CITY PLAN COMMISSION**THURSDAY, NOVEMBER 16, 2023****FILE NUMBER:** S234-010**SENIOR PLANNER:** Sharmila Shrestha**LOCATION:** Garden Grove Road, northwest of Beltline Road**DATE FILED:** October 20, 2023**ZONING:** PD 1096PD LINK: [Article 1096.pdf \(dallascityhall.com\)](#)**CITY COUNCIL DISTRICT:** 8**SIZE OF REQUEST:** 2.304-acres**APPLICANT/OWNER:** 1500 S Beltline, LLC**REQUEST:** An application to create one 2.304-acre lot from a tract of land in City Block 8821 on property located on Garden Grove Road, northwest of Beltline Road.**SUBDIVISION HISTORY:**

STAFF RECOMMENDATION: The request complies with the requirements of PD 1096; therefore, staff recommends approval of the request subject to compliance with the following conditions:**General Conditions:**

PRELIMINARY PLAT
1500 S. BELTLINE ADDITION
LOT 1, BLOCK B8821
 BEING A PLAT OF
 A TRACT OF SURVEY IN BLOCK 8821
 ROBERT KLEBERG SURVEY, ABSTRACT NO. 716
 CITY OF DALLAS, DALLAS COUNTY, TEXAS
 CITY PLAN FILE NO. S234-010
 ENGINEER PLAN NO. 3111-

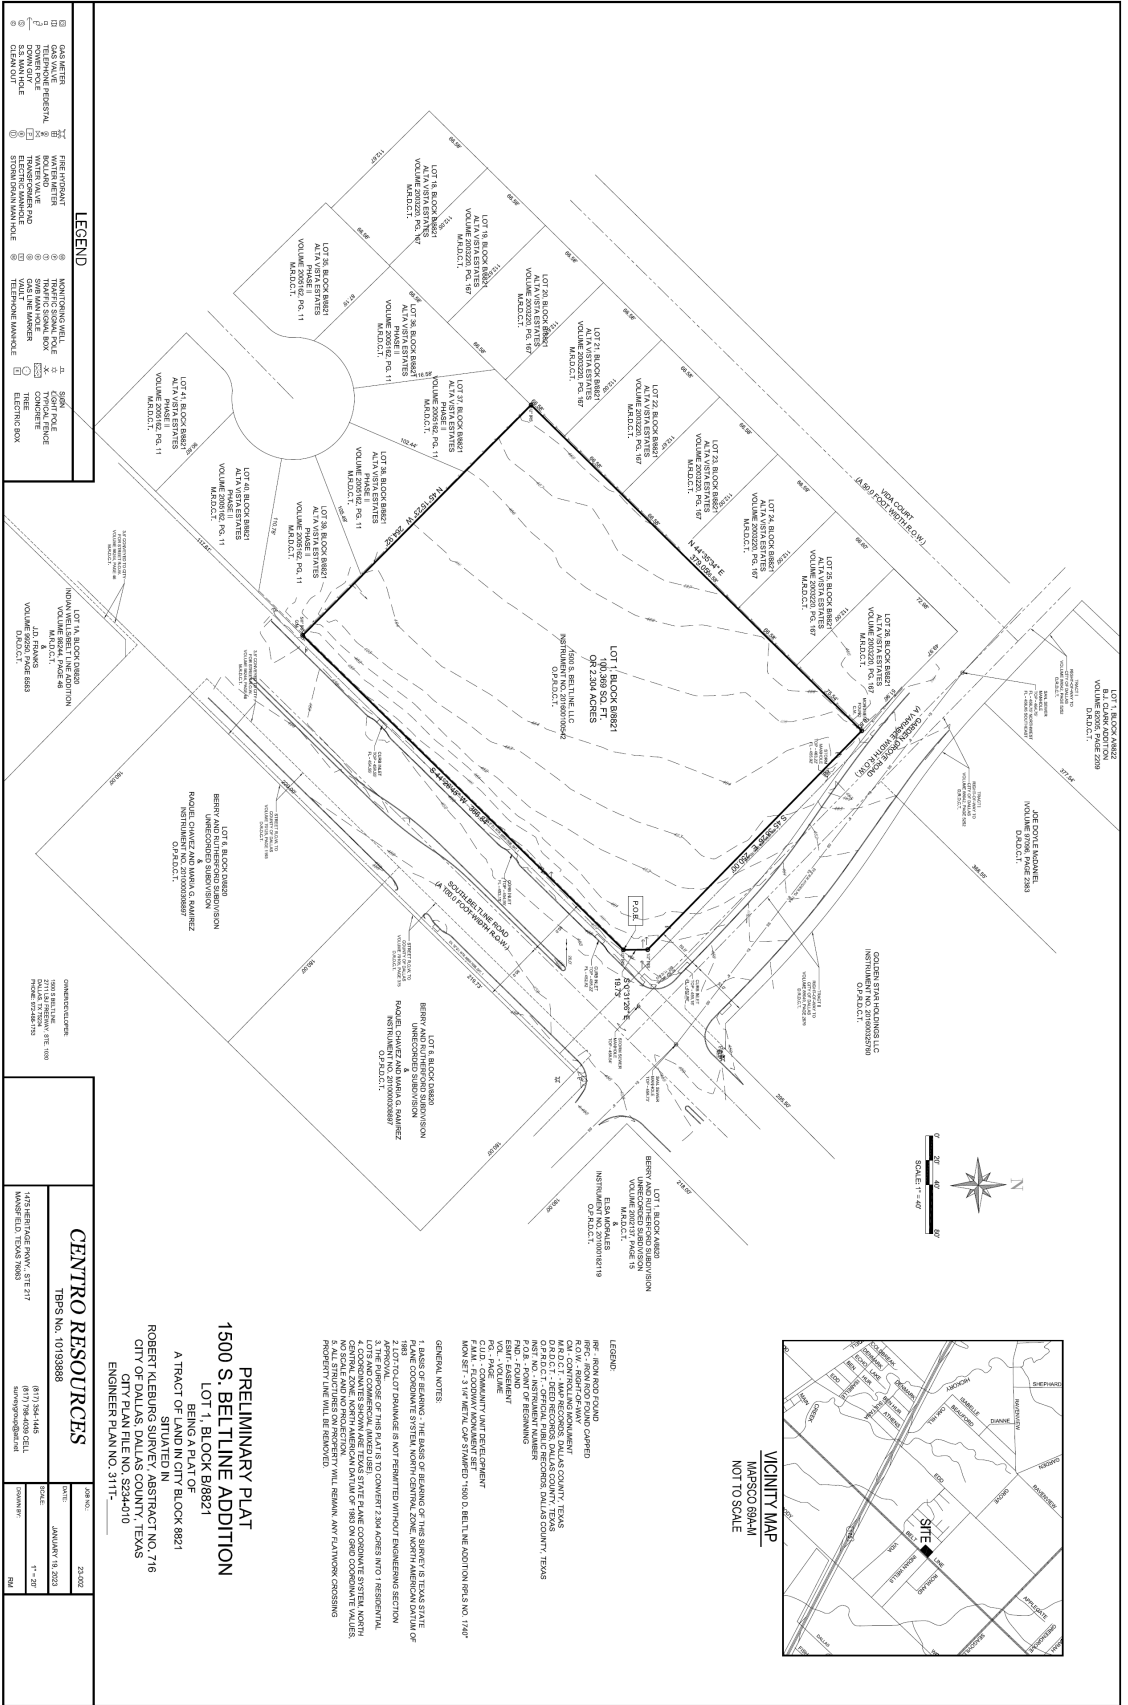
15. On the final plat, dedicate 53.5 feet of right-of-way (via fee simple) from the established center line of Beltline Road. Section 51A 8.602(c).
16. On the final plat, dedicate 30 feet of right-of-way (via fee simple) from the established center line of Garden Grove Road. Section 51A 8.602(c).

17. On the final plat, dedicate a minimum 5-foot by 5-foot corner clip (via fee simple or Street easement) at the intersection of Graden Grove Road & Beltline Road. Section 51A 8.602(d)(1).
18. A larger corner clip may be requested during engineering plan and traffic review to accommodate an adequate turning radius, or to maintain public/traffic appurtenances with the area of corner clip. Section 51A 8.602(d)(1), Section 51A-8.608(a)
19. Must coordinate with Transportation Department for any traffic signal requirements that are deemed necessary for improving pedestrian accessibility and safety related to site development. (Contact Srinivasa Veeramallu with Traffic Signals) Section 51A-8.606, 51A-8.608

20. Prior to final plat, submit a completed final plat checklist and all supporting documents.
21. On the final plat, show how all adjoining right-of-way was created.
22. On the final plat, show recording information on all existing easements within 150 feet of the property.
23. Plat name in Owners Dedication Statement does not match with the plat name on the Title Block. Plat names cannot begin with a number.

25. On the final plat, change “Garden Grove Road” to “Garden Grove Road (F.K.A. Crawford Road)”.
26. On the final plat, identify the property as Lot 1 in City Block L/8821.
